STAFF REPORT
(One-Step Final Plat)

CASE NUMBER: S/D 99-37 - WESTWOOD HILLS 3RD ADDITION

LOCATION: West side of Tyler, South of Maple

VICINITY MAP

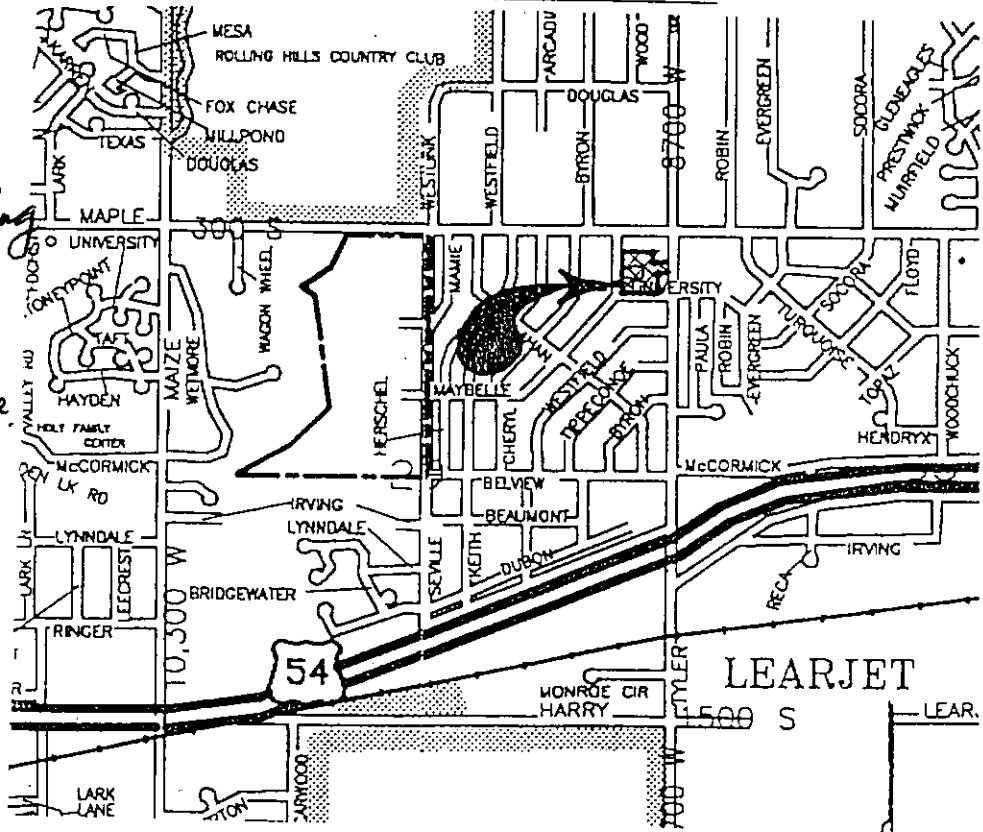
Ext. SS to lot 2 \$ Water

- A. It appears that sanitary sewer service is available. City Engineering needs to indicate if a revised petition for City water needs to be submitted.

- C. City Engineering needs to comment on the status of the applicant's drainage plan.
- D. In conformance with the CUP, the plat proposes one access opening along Tyler and one opening along University Avenue.

- G. As required by the sidewalk ordinance, sidewalks shall be provided along University Avenue and Maybelle Avenue. A sidewalk certificate shall be provided.
